NORTHERN STATES POWER COMPANY

MONTICELLO NUCLEAR GENERATING PLANT
Docket No. 50-263 License No. DPR-22

Planned Modifications to Permit Testing
To Be Conducted in Accordance with 10 CFR 50, Appendix J

Figure 1. Drywell Instrument Air Containment Penetration

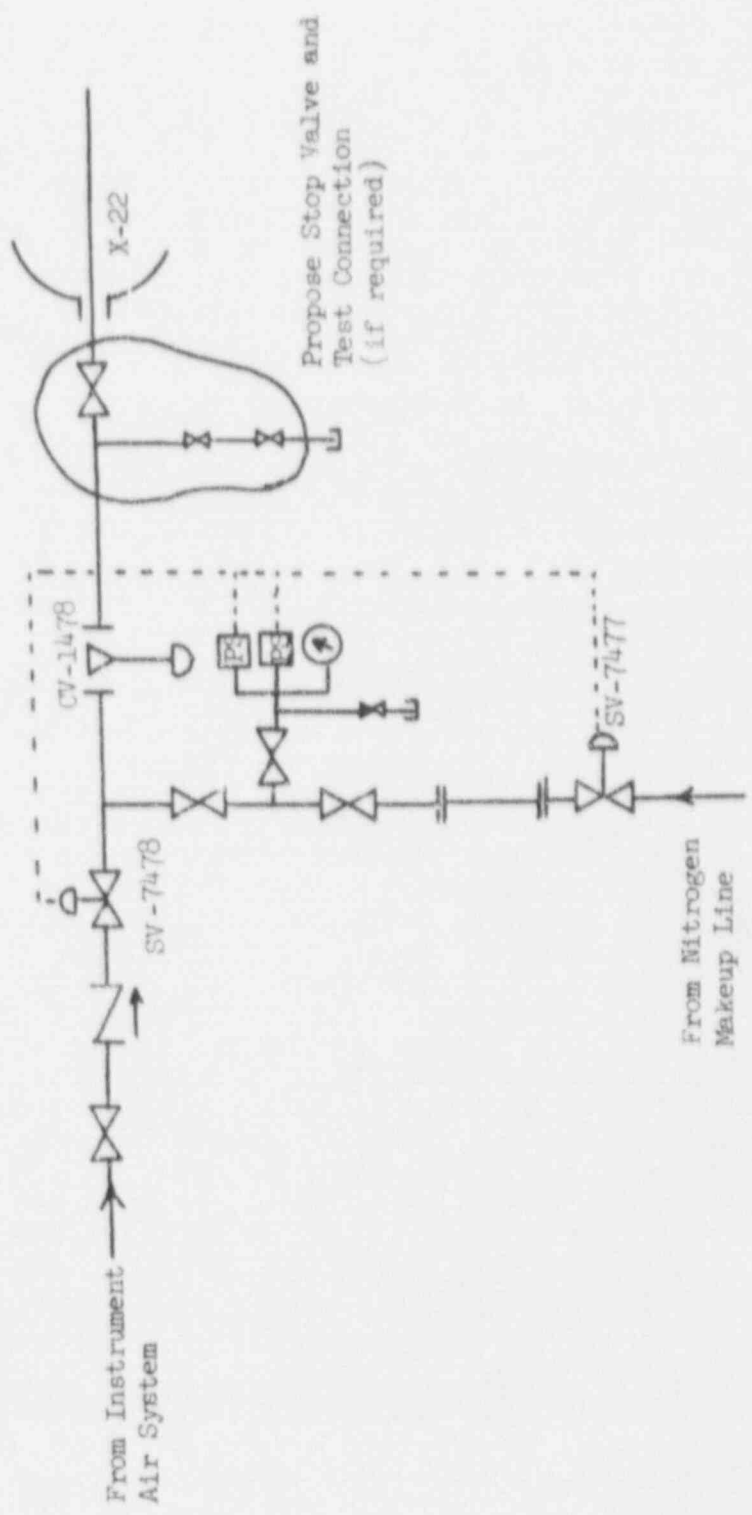
Further review of this penetration indicates that the control valve may be tested in the reverse direction utilizing sections of piping installed as part of a plant modification to supply nitrogen to the drywell instrument air header. Testing this valve in the reverse direction will yield a conservative leakage rate measurement.

If testing of this valve is found to be impractical using this method, a test connection and stop valve can be added to the instrument air line to permit Type C testing (Figure 1).

Figure 2. Cooling Water Supply and Return From Drywell
Containment Penetrations

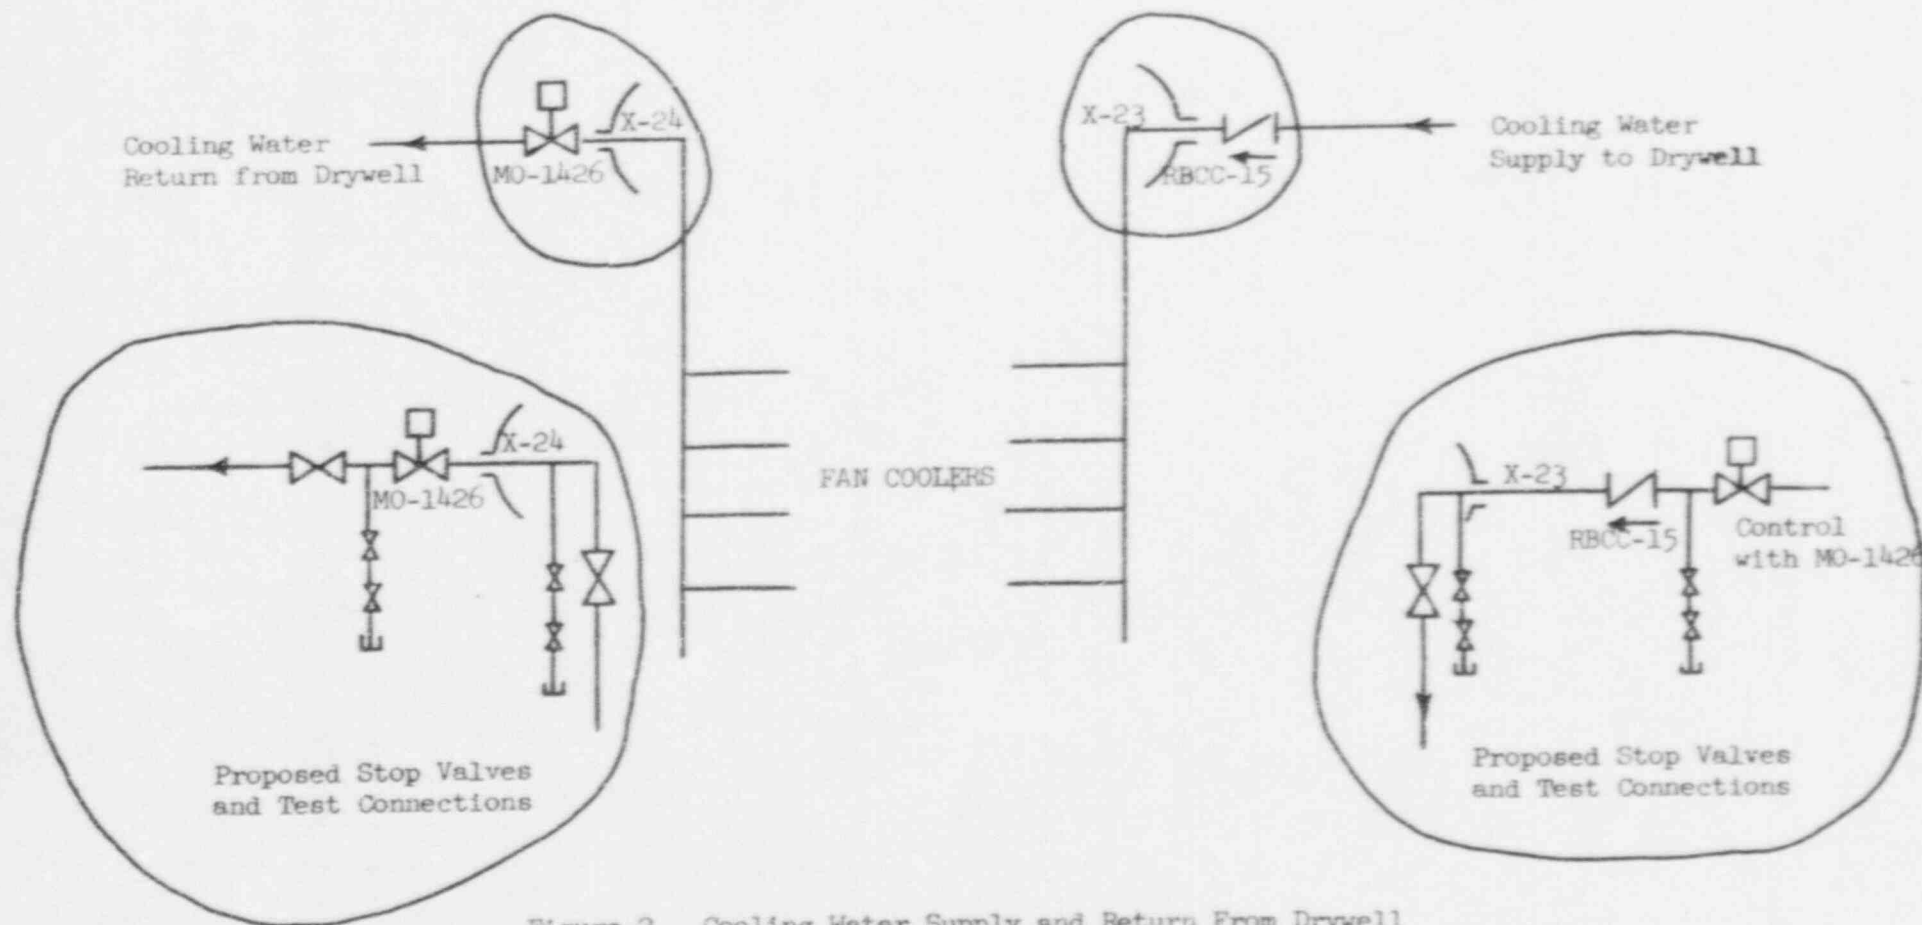
Test connections and stop valves can be added to the cooling water supply and return lines (Figure 2) to allow Type C tests.

Figure 3. TIP and TIP Purge Containment Penetrations

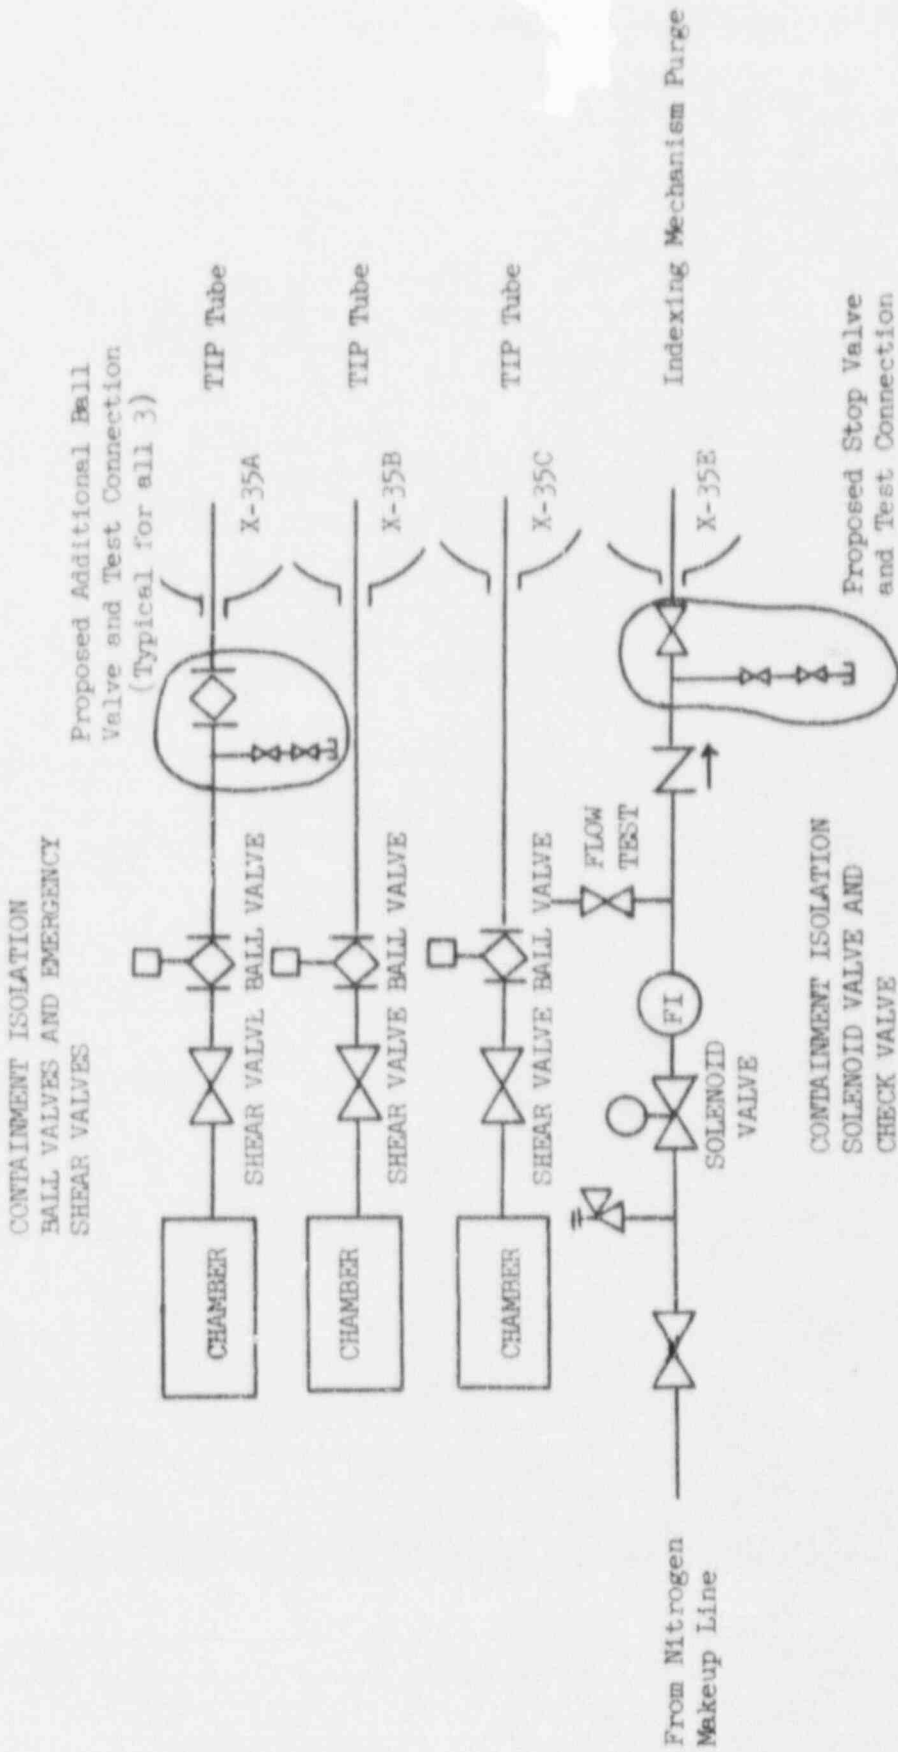
An additional ball valve and test connection can be installed in each TIP line to permit leakage testing of the ball valve. An additional stop valve and test connection can be installed in the nitrogen purge supply line to permit leakage testing of the check valve (Figure 3).

Figure 4. CRD Hydraulic Return Containment Penetration

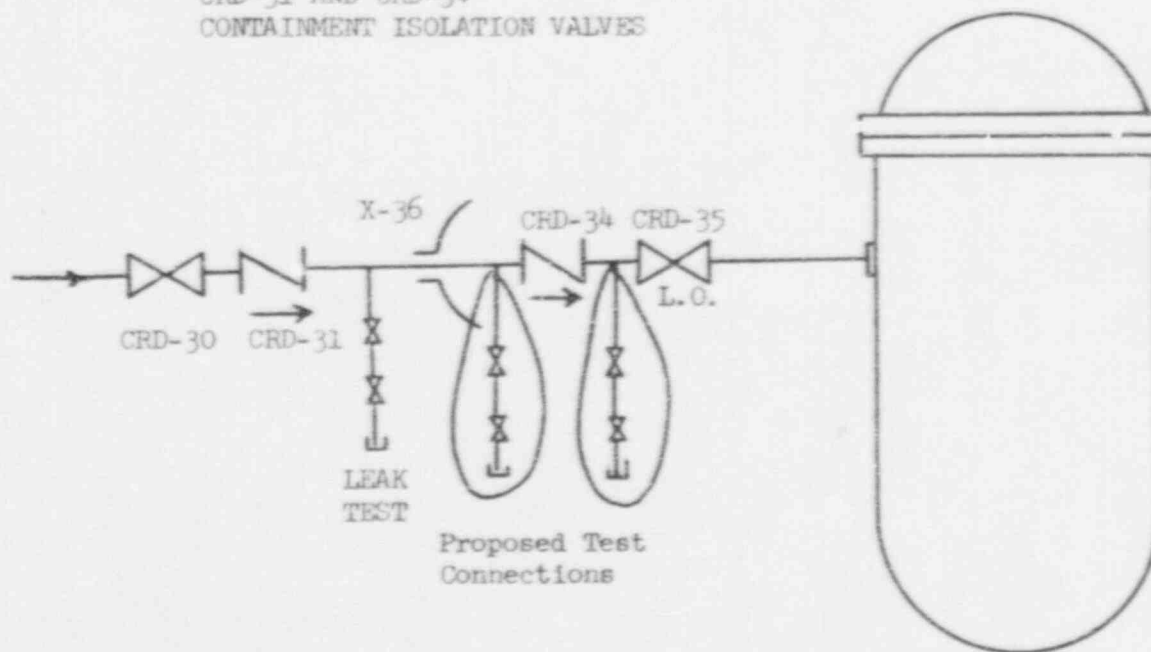
Additional test connections can be added on each side of the inboard check valve to allow Type C testing of this valve. Only the outboard check valve is now testable (Figure 4).

Figure 5. SBLC Containment Penetration

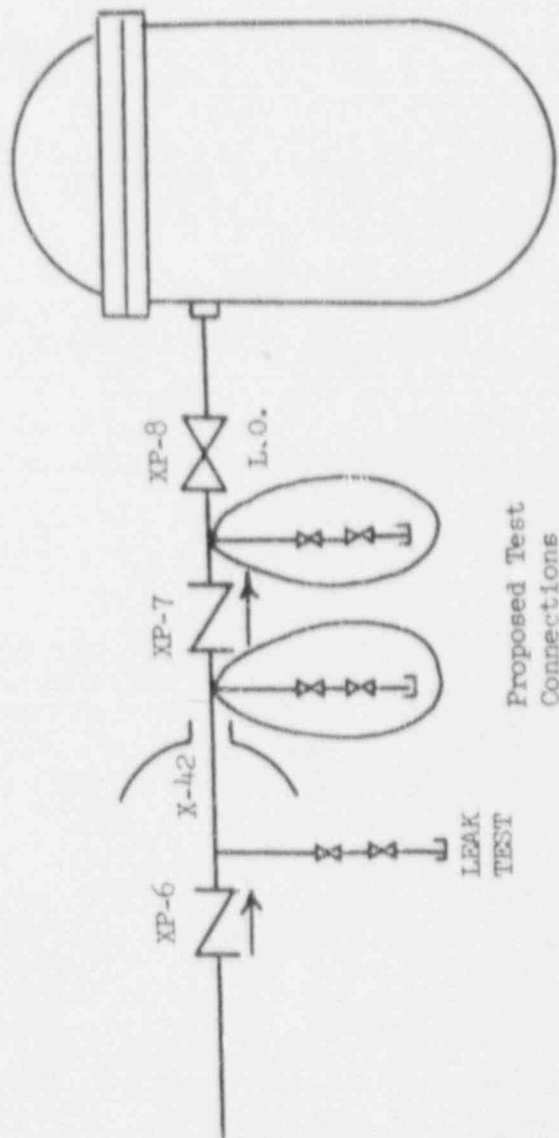
Additional test connections can be added on each side of the inboard check valve to allow Type C testing of this valve. Only the outboard check valve is now testable (Figure 5).

Figure 6. HPCI Turbine Exhaust Containment Penetration

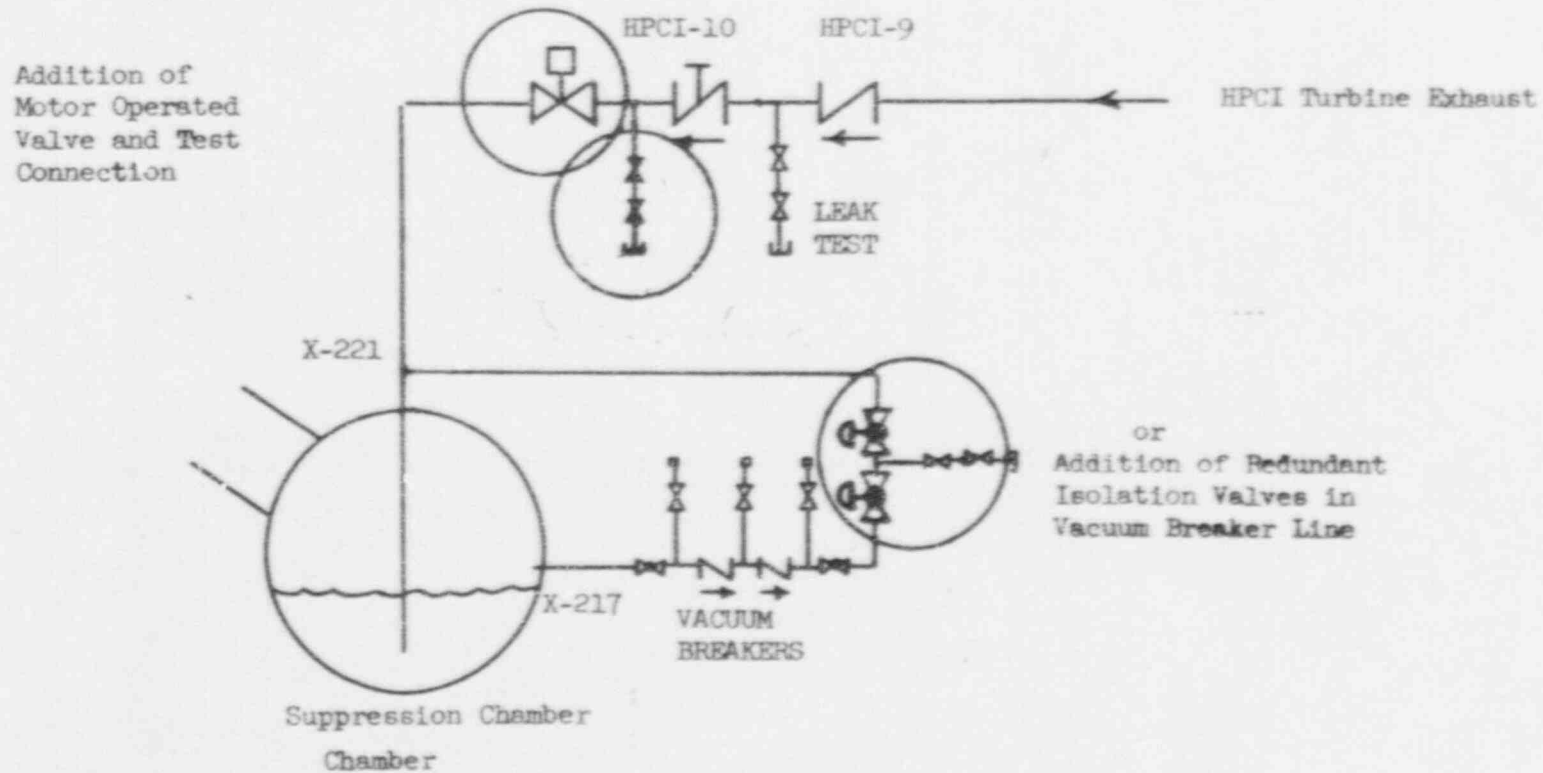
The check valves serving as containment isolation for the HPCI turbine steam exhaust line have a history of excessive leakage. Two check valves are installed, one of which is subjected to periodic Type C tests.

Two different modifications are being considered to resolve this problem (Figure 6). The first modification involves installing an additional motor operated valve in the turbine exhaust line. This valve would be subjected to periodic Type C tests and would be considered the containment

isolation valve in this line. The second modification involves installing redundant isolation valves in the vacuum breaker line. These valves would receive Group 4 isolation signals and would preclude the entry of the post LOCA torus atmosphere into this line. A water seal would then be provided by the water in the suppression pool.

Figure 7. RCIC Turbine Exhaust Containment Penetration

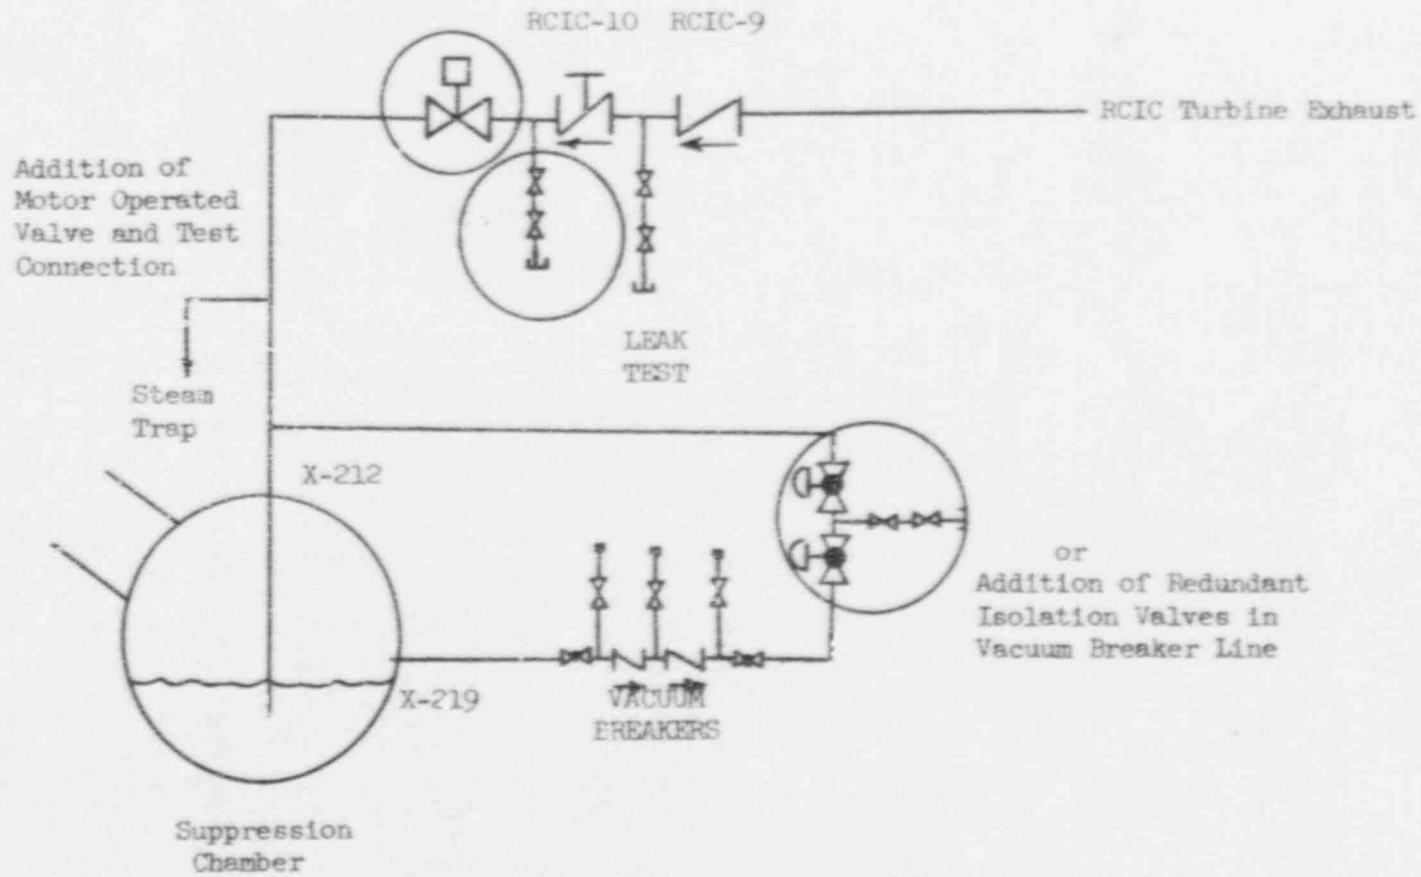
The check valves serving as containment isolation for the RCIC turbine steam exhaust line have a history of excessive leakage. As in the case of the HPCI system, two check valves are installed. One of these valves satisfies the minimum requirements for containment isolation and is subjected to periodic Type C tests. The other valve (the inboard check valve) cannot be tested in accordance with Appendix J.

Two different modifications are being considered to resolve the check valve leakage problems (Figure 7). These modifications are identical to those being considered for the HPCI system. The first modification involves installing an additional motor operated valve in the turbine exhaust line. The alternate modification involves installing redundant isolation valves in the vacuum breaker line. These valves would receive Group 5 isolation signals.

Figure 8. Demineralized Water Supply Containment Penetration

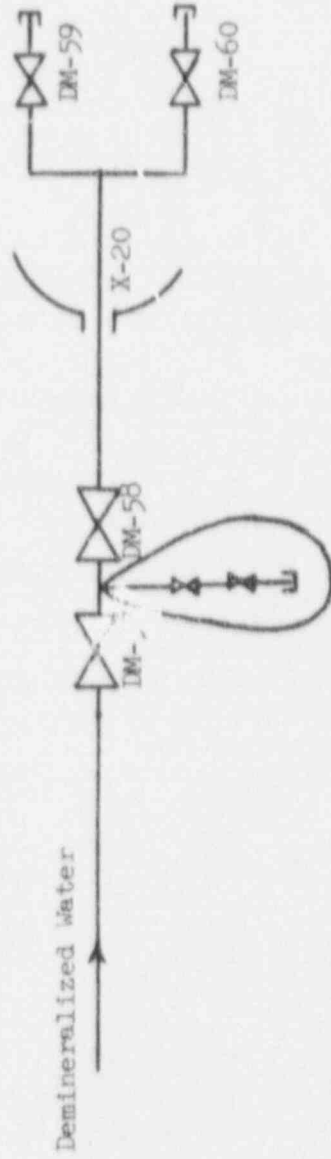
A test connection can be installed to permit Type C testing of the two manual valves in this line (Figure 8).

Figure 9. Service Air Supply Containment Penetration

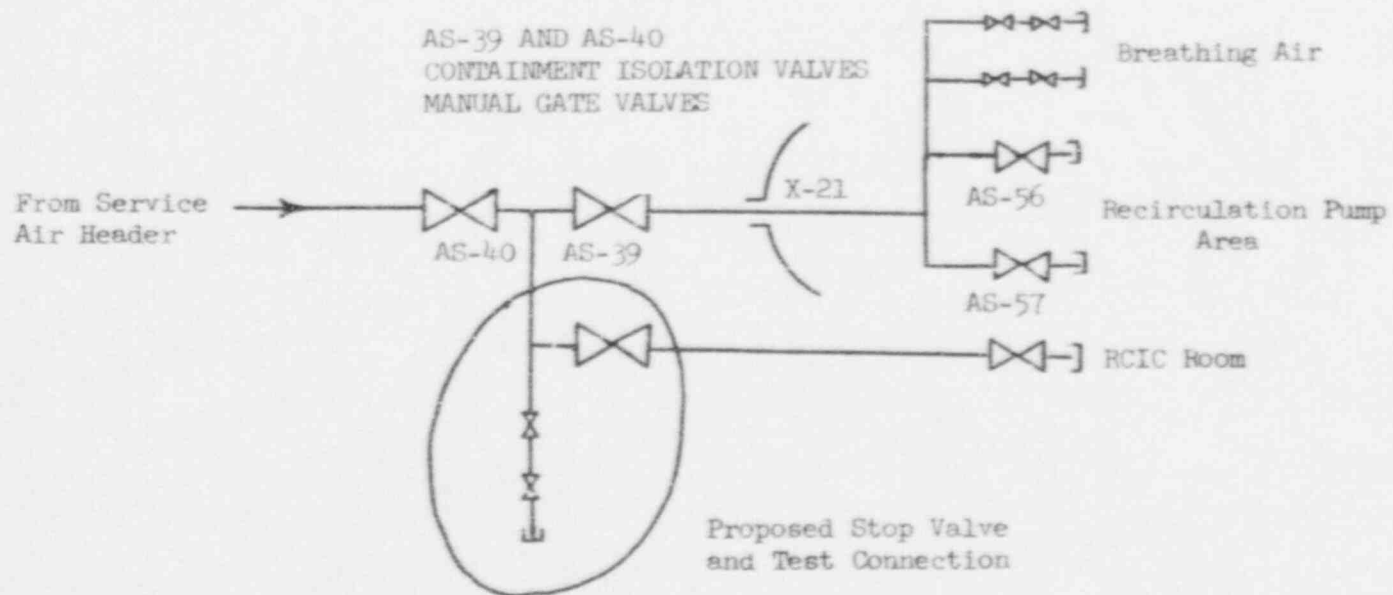
A test connection and additional stop valve can be installed to permit Type C testing of this penetration (Figure 9).

Figure 10. Torus Instrument Air Supply Containment Penetration

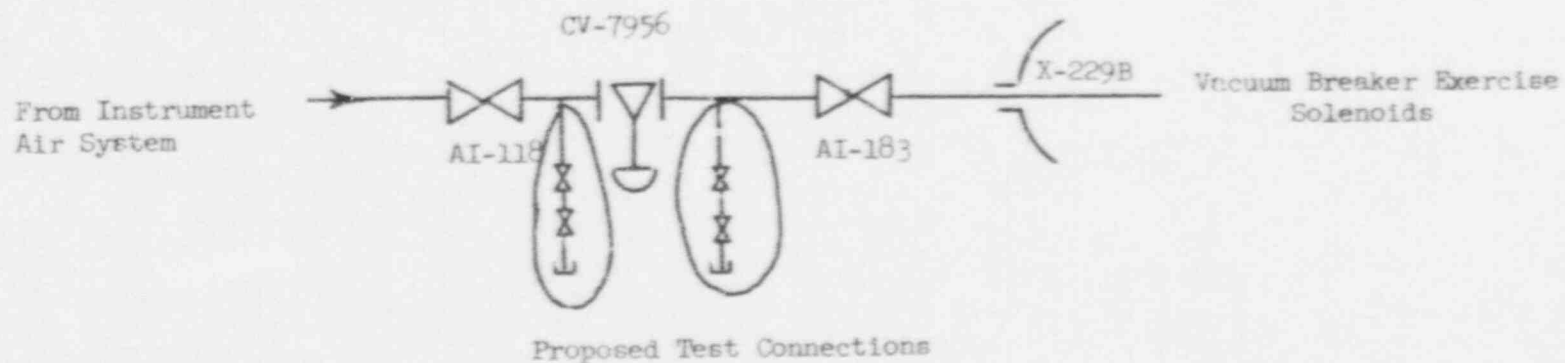
A plant modification was recently completed which added an instrument air supply line to the torus for vacuum breaker exercising (Figure 10). Test connections can be added to this line to permit Type C testing of the control valve.
